Office Action Summary	Application No. 10/799,044	Applicant(s) SAMAIN ET AL.	
	Examiner Noah C. Hawk	Art Unit 3636

DETAILED ACTION

Nakane et al. '803, Figure 2

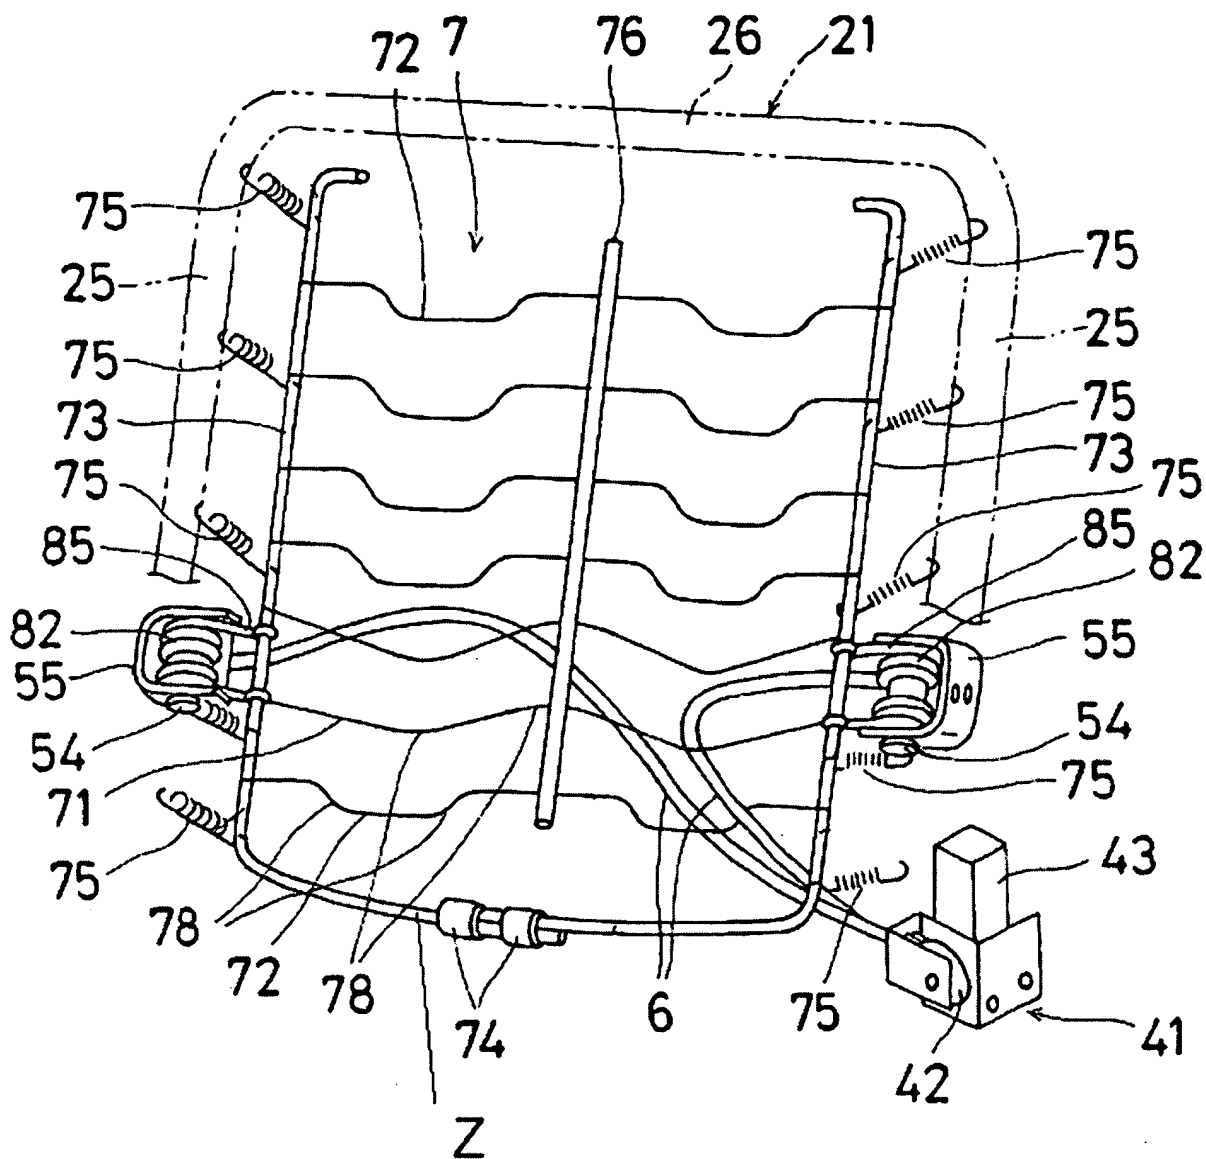
13. Claims 1, 10 and 11 are rejected under 35 U.S.C. 102(b) as being anticipated by Nakane et al. in US Patent 6499803. Nakane teaches a support structure having side rails (73), crossbars (Z) and a plurality of transverse wires (72) with an average bending stiffness less than that of the crossbars (the fact that the wires are thinner than the cross bars implies that they are less stiff than the cross bars.) Nakane further teaches a plurality of links (75) fixedly attached to the side rails and the seat frame (25).

McMillen et al. '501, Figure 2

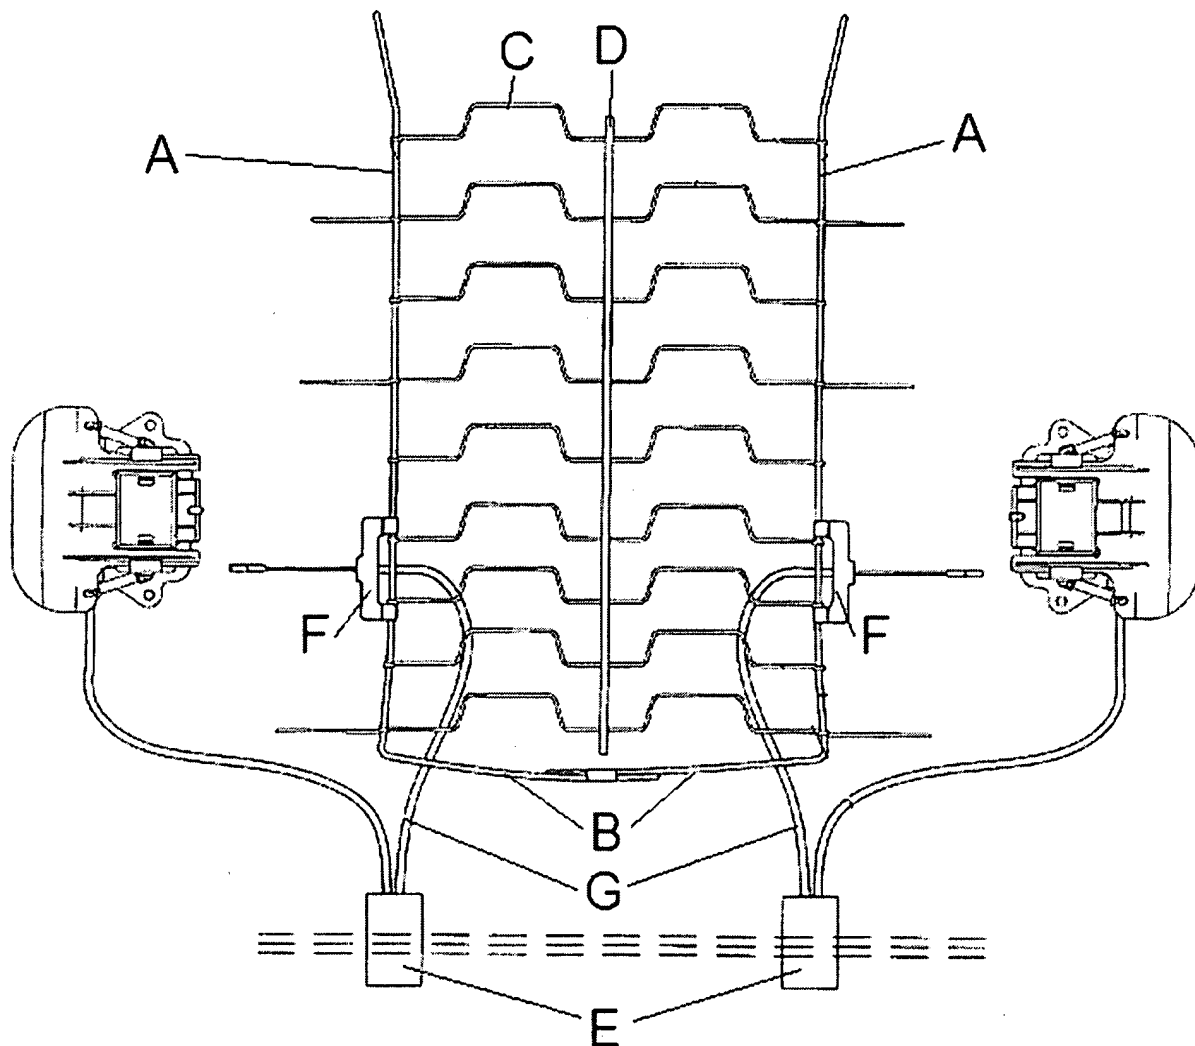
a. Regarding Claims 1 and 17, McMillen teaches a support structure comprising a pair of side rails (A, best seen in McMillen Figure 2, below), a pair

of cross bars (B, formed by portions of the side rails) and a plurality of transverse wires (C) with a bending stiffness less than that of the crossbars (the fact that the crossbars are thicker than the transverse wires implies that the crossbars are stiffer than the wires).

- b. Regarding Claim 2, McMillen further teaches that the crossbars are fixedly attached to the side rails with a clip (best seen in McMillen, Figure 2).
